STATE OF NORTH CAROLINA DEPARTMENT OF TRANSPORTATION

Asphalt Wearing Surface on Approach Slab Detail

DETAIL OF ASPHALT WEARING SURFACE ON APPROACH SLAB

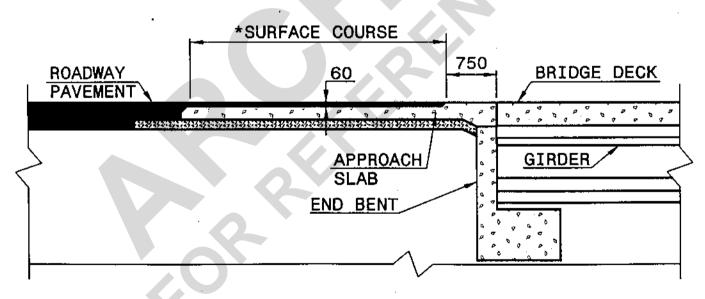
Recently, there has been confusion regarding the depth of asphalt wearing surface to be specified on the "Asphalt Wearing Surface on Approach Slab" detail. After discussion with the Structure Design, Pavement Management, and Roadway Design Units, it has been determined:

- 1. The notch in the approach slab will remain at a fixed dimension of 60mm(2 ½ in.).
- 2. The attached detail will be included with the typical sections in the plans. The revised detail is now available in the Roadway Design Cell Library.
